# Access Compliance Report

## Public Rights-of-Way

Intersection ID: 31764	Main Street: CAROB_TREE_LN	Cross Street: STARNES_RANDALL_RD	Location: NW
ADA ID: 5190E99D5B78	Ramp Type: PerpDiag	Initial Pass/Fail: Pass	Overall Compliance: No
Severity Score: 0.25			
Codes/Mitigation Info/Possible Solution		Field Measurements/Component Compliance

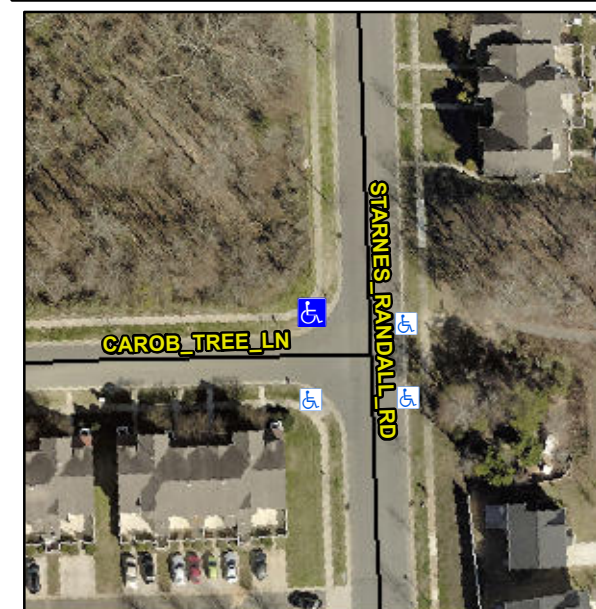
**Not Found, R304.5.3, R304.2.2-Perp, R304.3.2-Para**

Compliance	Description	Data	Compliance	Description	Data
N/A	Ramp Length (in)	87.5	Yes	Ramp Slope (%)	7.4
Yes	Ramp Width (in)	48.0	No	Ramp XSlope (%)	3.4
N/A	Flare Type LT	Sloped	N/A	Flare Type RT	N/A
N/A	Flare Slope LT (%)	3.1	Yes	Flare Slope RT (%)	8.5
N/A	Flare Traversable LT?	Yes	N/A	Flare Traversable RT?	Yes
Yes	Landing Length (in)	48.0	Yes	DWS Provided?	Yes
Yes	Landing Width (in)	48.0	Yes	DWS Contrast?	Yes
No	Landing Slope (%)	4.0	Yes	DWS Length (in)	24.0
No	Landing X Slope (%)	2.8	Yes	DWS Full Width?	Yes
N/A	Landing Curb? (Y/N)	No	Yes	DWS Offset (in)	0.0
N/A	Shared Landing?	Yes			
Yes	Gutter Ponding?	No	Yes	Gutter Slope (%)	5.0
Yes	Gutter Lip Ht (in)	0.0	No	Gutter X Slope (%)	3.5
N/A	Painted X Walk1?	No	N/A	Painted X Walk2?	No
	X Walk 1 Direction	To S		X Walk 2 Direction	To E
N/A	X Walk 1 Width (in)	N/A	N/A	X Walk 2 Width (in)	N/A
	X Walk 1 Slope (%)	1.3		X Walk 2 Slope (%)	2.7
	X Walk 1 X Slope (%)	2.5		X Walk 2 X Slope (%)	1.6

**Remove & Replace Curb Ramp With Two New Directional Ramps or Equivalent. Remove & Replace Gutter.**
